Addendum No.: 01

Date Of Addendum: 3/16/2021

**BUSINESS SCHOOL INSTRUCTIONAL FACILITY
SOUTHERN CT STATE UNIVERSITY
BI – RS– 337**

The following clarifications are applicable to drawings and specifications for the project referenced above.

B-SKL-01

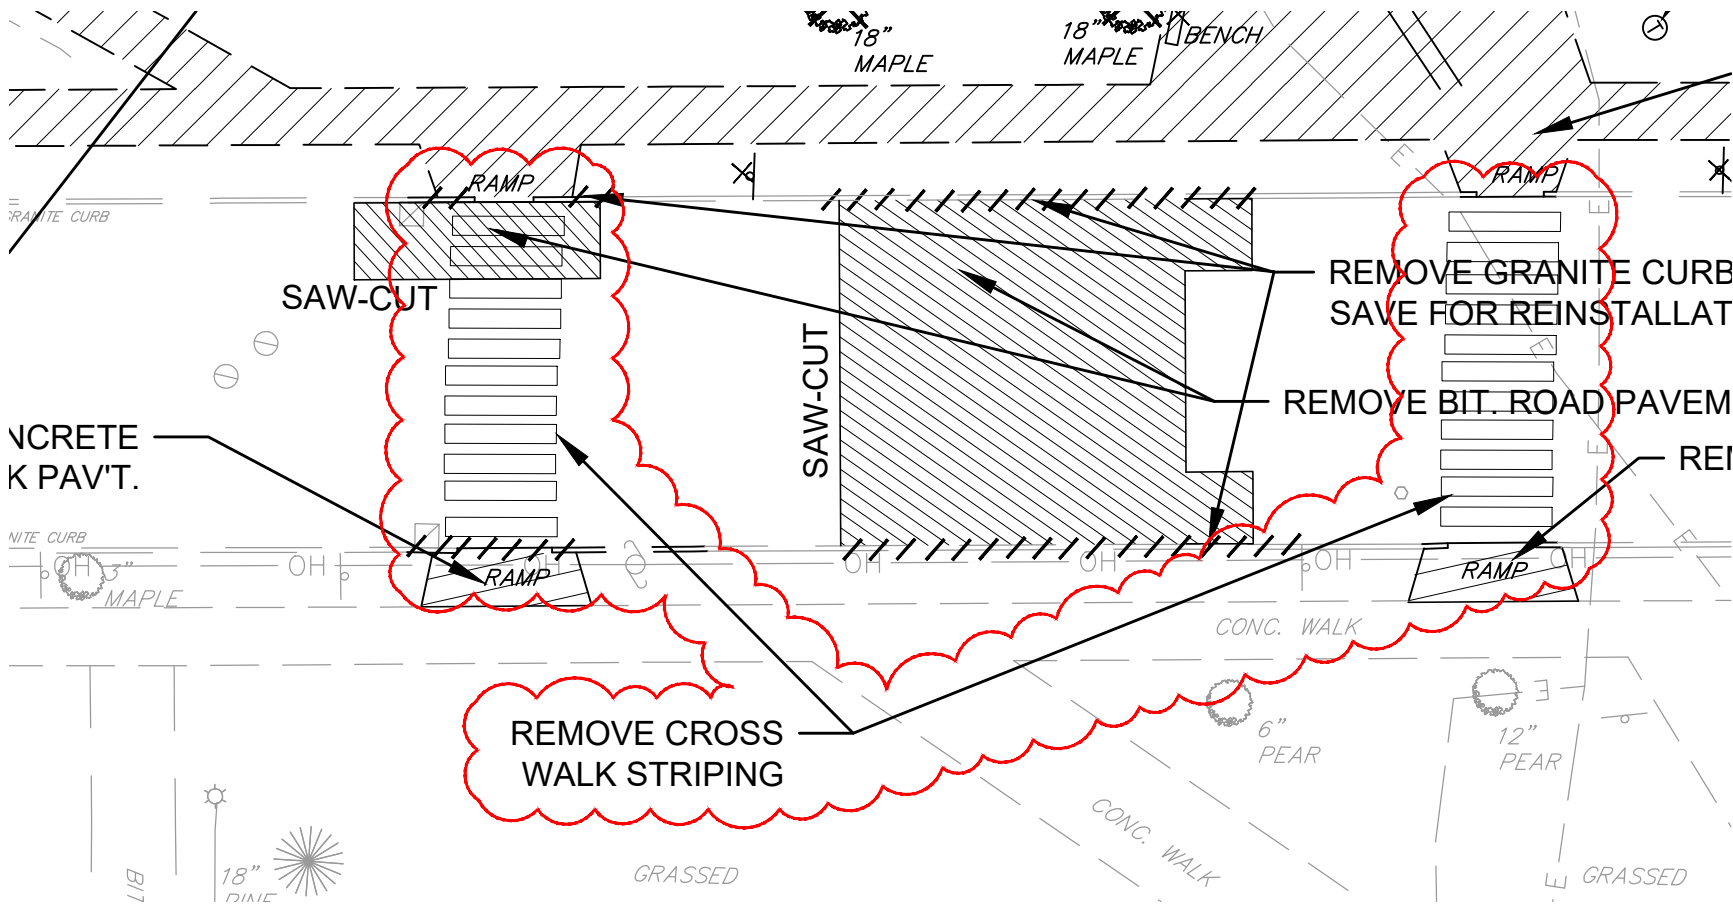
B-SKL-01: Add removal of existing crosswalk striping in Farnham Avenue

REMOVE CROSS
WALK STRIPING

ADDENDUM 01: EXISTING SIGNS & CROSS WALK SIGNAL
 BUSINESS SCHOOL INSTRUCTIONAL FACILITY
 BI-RS-337
 10 WINTERGREEN AVENUE
 NEW HAVEN, CT

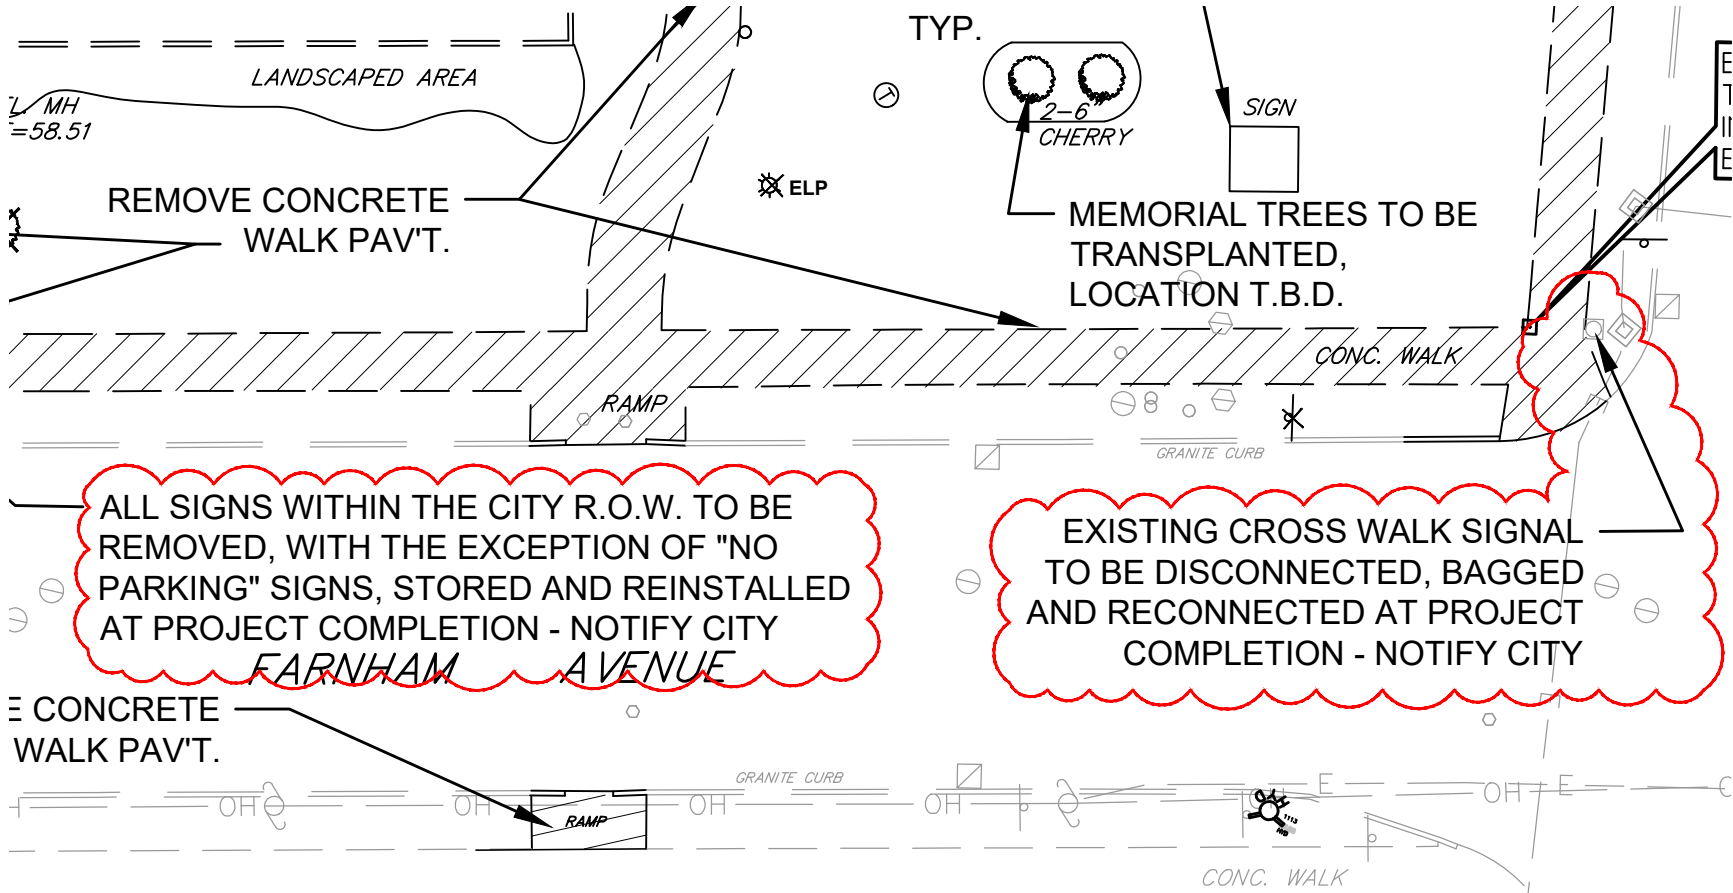
- Existing crosswalk signal at Farnham/Wintergreen to be disconnected and “bagged” rather than removed, stored and replaced.
- Existing traffic signs to be removed and replaced EXCLUDING “No Parking” signs
- Pre-construction meeting with City required to review signs

ALL SIGNS WITHIN THE CITY R.O.W. TO BE REMOVED, WITH THE EXCEPTION OF "NO PARKING" SIGNS, STORED AND REINSTALLED AT PROJECT COMPLETION - NOTIFY CITY

EXISTING CROSS WALK SIGNAL TO BE DISCONNECTED, BAGGED AND RECONNECTED AT PROJECT COMPLETION - NOTIFY CITY

PER CITY TRAFFIC AUTHORITY "NO PARKING" SIGNS ARE TO REMAIN IN PLACE. A PRE-CONSTRUCTION SITE MEETING WITH THE CITY OF NEW HAVEN IS REQUIRED TO REVIEW ALL WORK WITHIN THE CITY R.O.W. PRIOR TO ANY DEMO OR REMOVALS

B-SKL-04

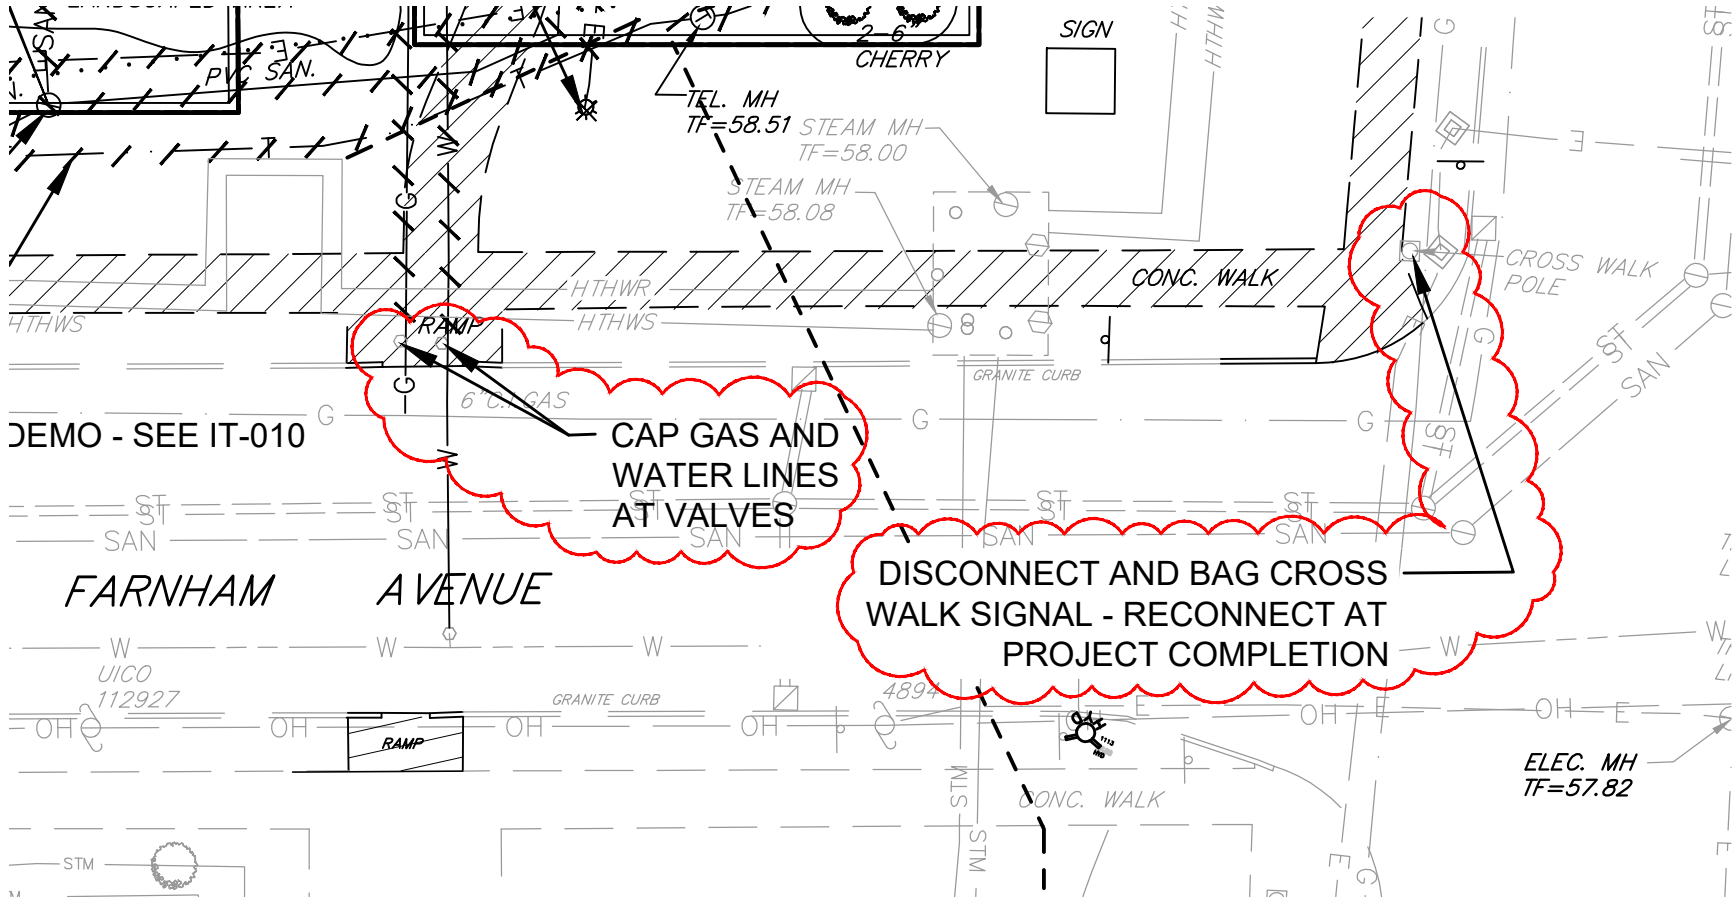
B-SKL-04: Existing gas and water to be capped at valves (Same note about crosswalk signal as B-SKL-02)

ADDENDUM 01: RAISED CROSS WALK
 BUSINESS SCHOOL INSTRUCTIONAL FACILITY
 BI-RS-337
 10 WINTERGREEN AVENUE
 NEW HAVEN, CT

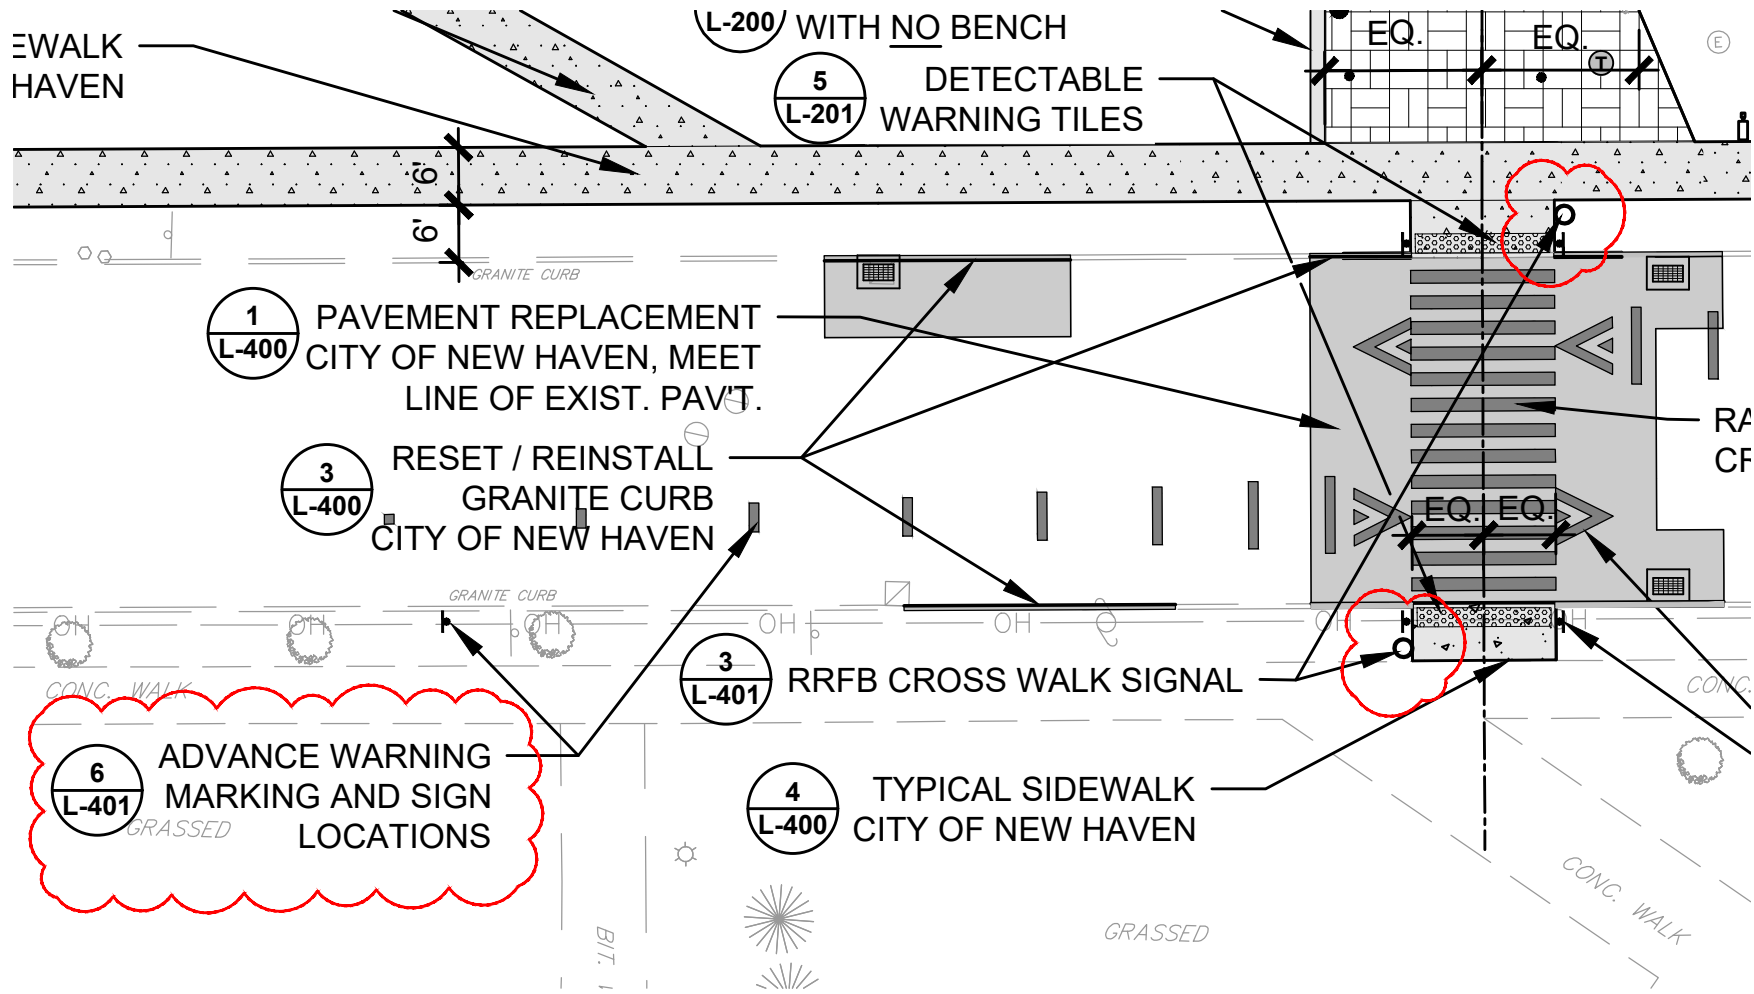
- Add callout for Advanced Warning Marking
- RRFB poles moved to opposite side of approach walk

**ADDED CALLOUT FOR "ADVANCED MARKINGS" TO SOUTH SIDE TO MATCH CITY TRAFFIC AUTHORITY APPROVED PLANS
RRFB POLES MOVED TO OPPOSITE SIDE OF PERPENDICULAR SIDEWALK APPROACH**

B-SKL-06

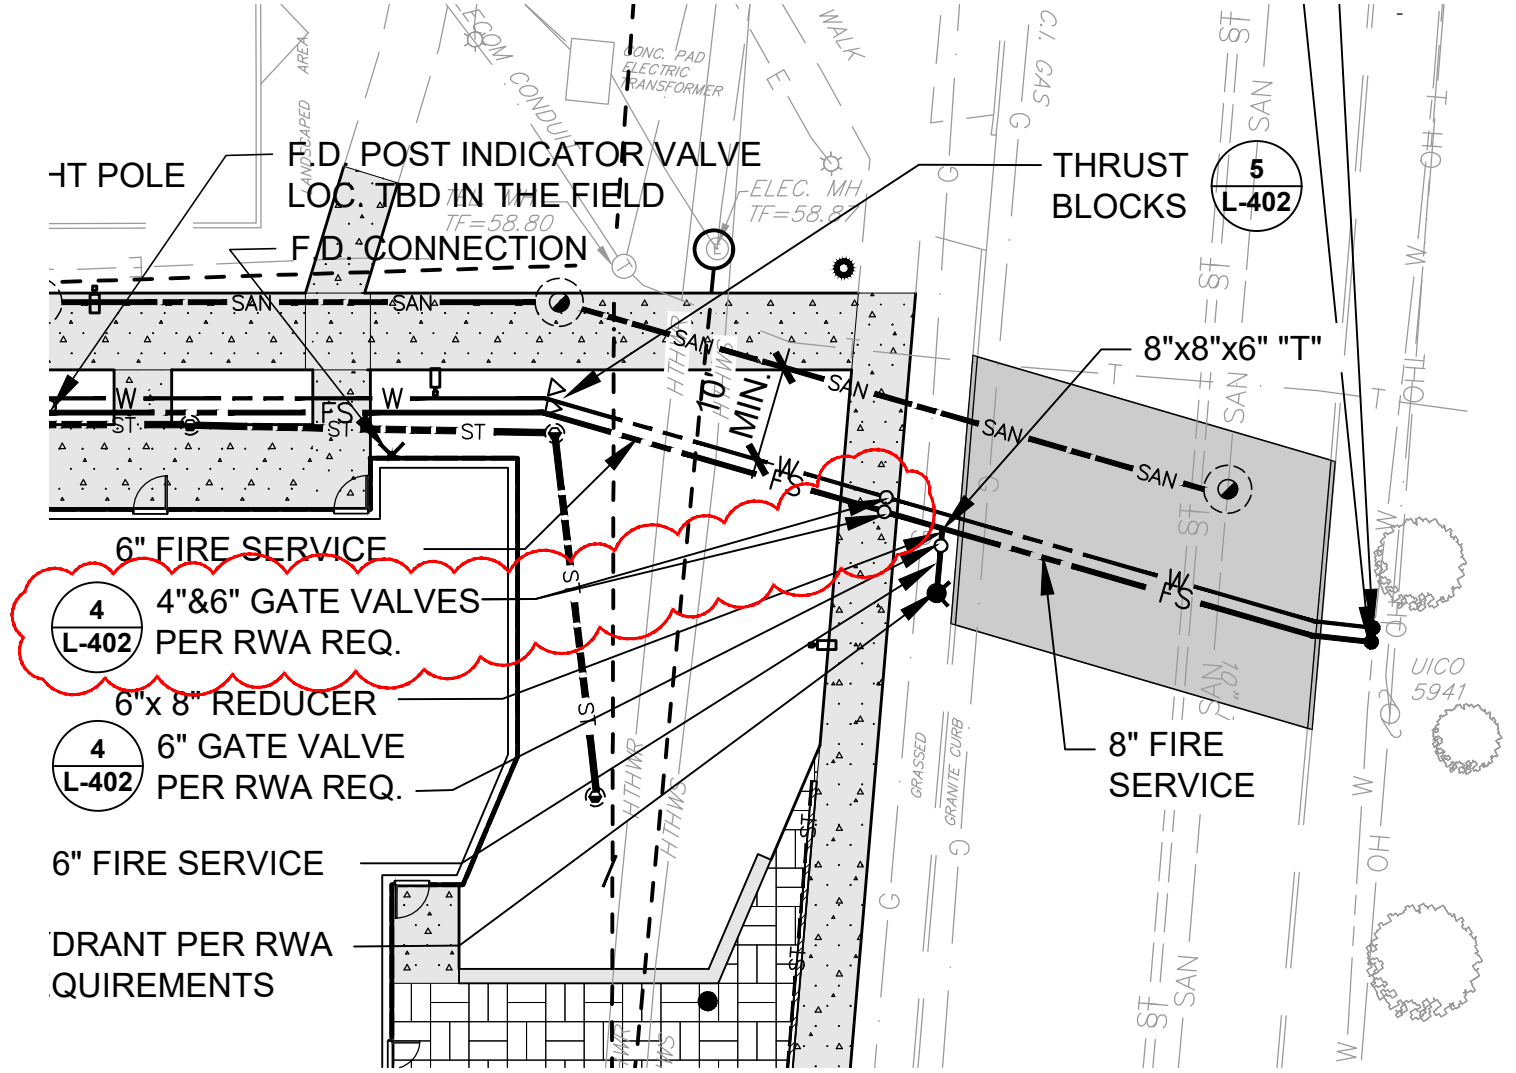
B-SKL-06: Water and Fire Service gate valves moved

**GATE VALVE LOCATION CHANGE
FOR DOMESTIC AND FIRE SERVICE**

B-SKL-07

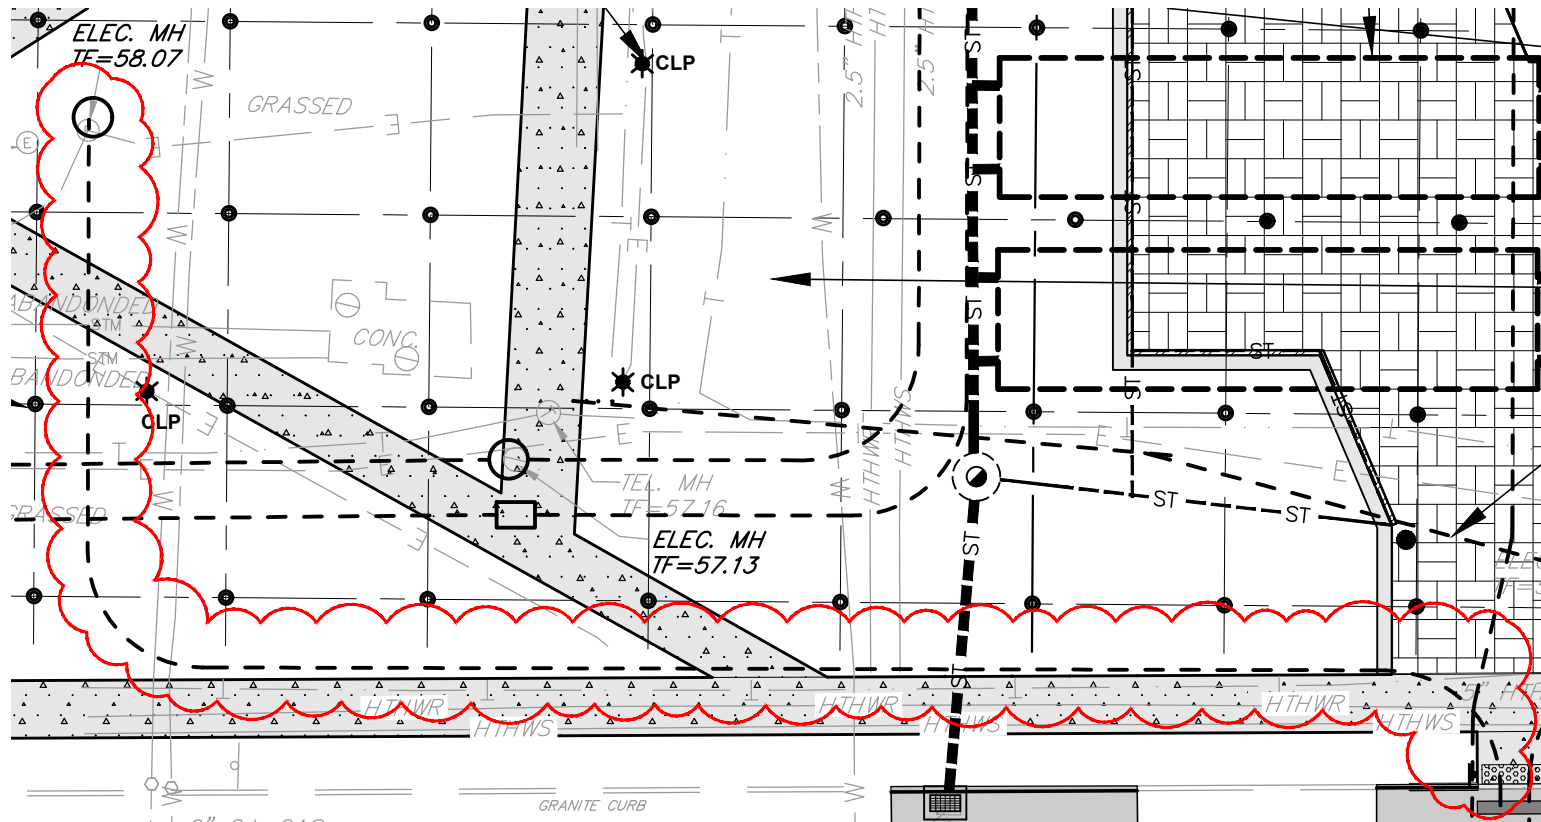
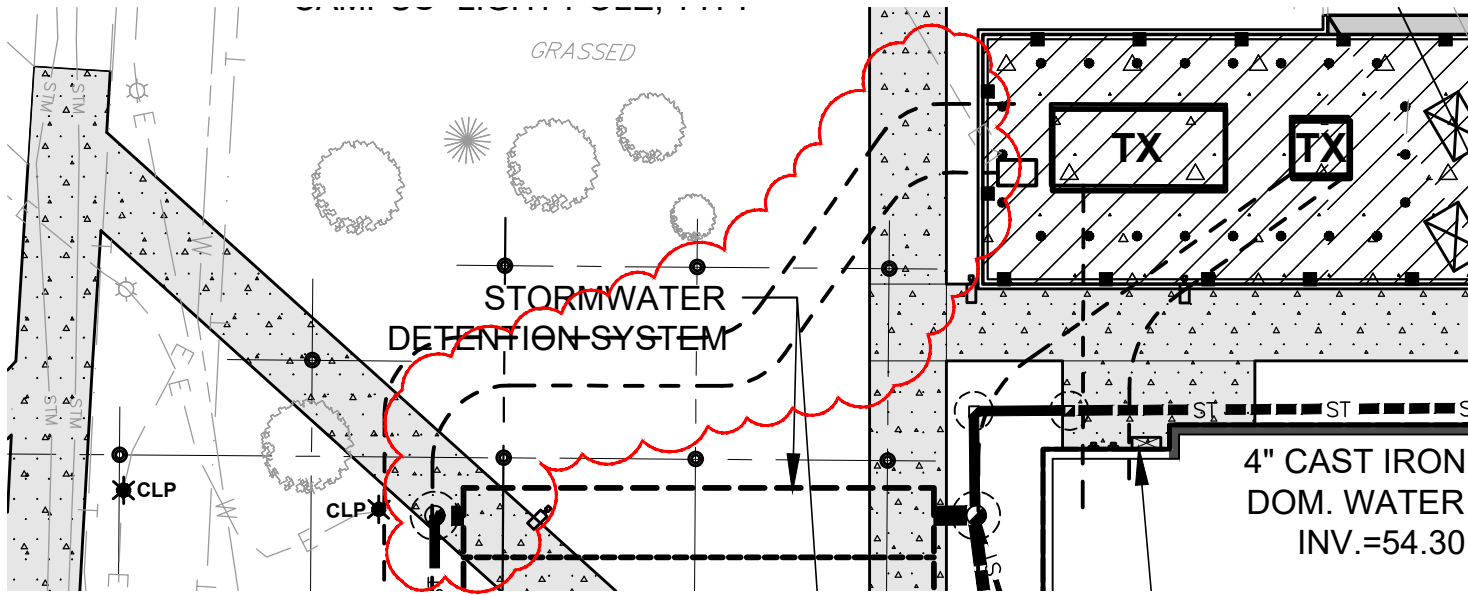
B-SKL-07: Electrical Service route revised

ELECTRICAL SERVICE ROUTE CHANGED TO AVOID LARGE TREES SEE E-011

ELECTRICAL SERVICE ROUTE CHANGE SEE E-011
